SUNDRY NOTICES AND REPORTS ON WELLS

OXY Excalibur 1
Federal

30-015-30771

OXY USA WTP LP - Proposed
OXY Excalibur Federal #1
API No. 30-015-30771

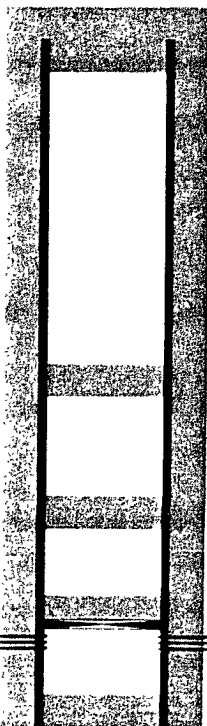
40
25sx @ 7675-7575' 6054-5954'

45
25sx @ 8335-8235' 8912-8812'

1. Approval is granted to P/A this well with the following modifications to the program:
2. A 45 sack plug; using class H cement, will be set @ 8912' to cover the top of the Morrow formation.
3. The top of the Wolfcamp will be covered by a 40 sack plug @ 6054'. This plug and all other plugs can use class C cement.
4. All of the plugs in the submitted procedure below 5800' can be eliminated.
5. The surface plug must be circulated to the surface from 100 feet.

*** All plugs, including the surface plug, should leave at least 25 sacks of cement inside the casing and be at least 100 feet, plus an additional 10% for each 1000 feet of depth.**
